UNITED STATES PATENT AND TRADEMARK OFFICE

APPLICATION NO.	FILING DATE	FIRST NAMED INVENTOR	ATTORNEY DOCKET NO.	CONFIRMATION NO.
10/826,432	04/16/2004	David Allen Kastrup	140728	9853
29399 7590 09/15/2008 JOHN S. BEULICK (12729) C/O ARMSTRONG TEASDALE LLP ONE METROPOLITAN SQUARE SUITE 2600 ST. LOUIS, MO 63102-2740				
			EXAMINER NGUYEN, ANDREW H	
			ART UNIT 3746	PAPER NUMBER
			NOTIFICATION DATE 09/15/2008	DELIVERY MODE ELECTRONIC

Office Action Summary

DETAILED ACTION

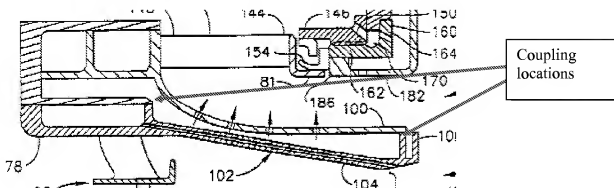
Regarding reference Bibler:

With regard to Applicant's assertion that Bibler fails to teach "a swirler coupled to the venturi to facilitate preventing a flow of fuel ... at upstream and downstream portions", Examiner

asserts that the swirler and venturi are coupled such that there is no passage for fuel to flow at the upstream and downstream portions. See the drawing below.
